## SUNDRY NOTICES AND REPORTS ON WELLS

Bone Flats 12 Federal #5

30-015-28847

**Temporary Abandonment of Wells on Federal Lands  
Conditions of Approval**

OXY USA WTP LP  
Bone Flats 12 Federal #5  
API No. 30-015-28847

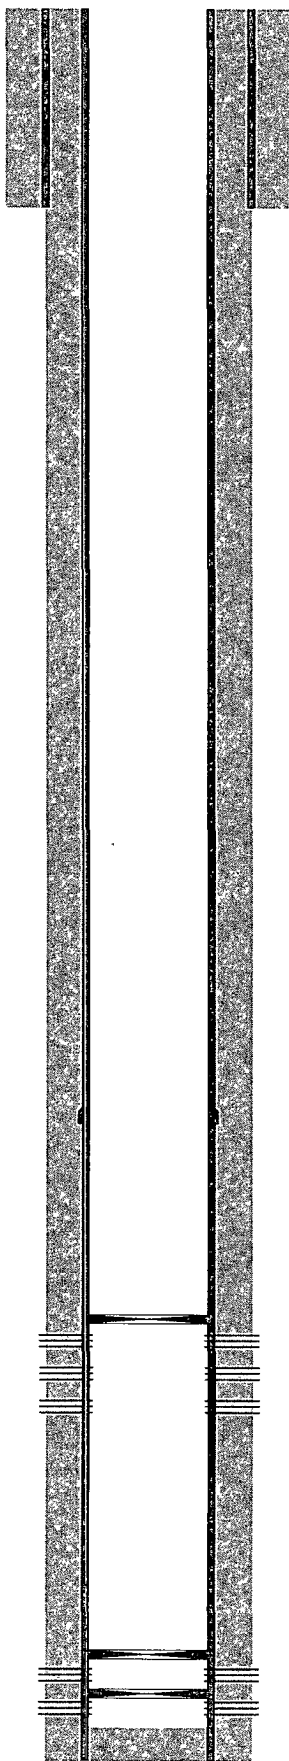
**Bone Flats 12 Federal #5**

1. Well may be approved to be TA/SI for a period of 9 months or until 11/09/2012 after successful MIT and subsequent report is submitted.
2. This will be the last TA approval for this well.
3. Well must be returned to production or plans to P&A must be submitted by October 1, 2012.
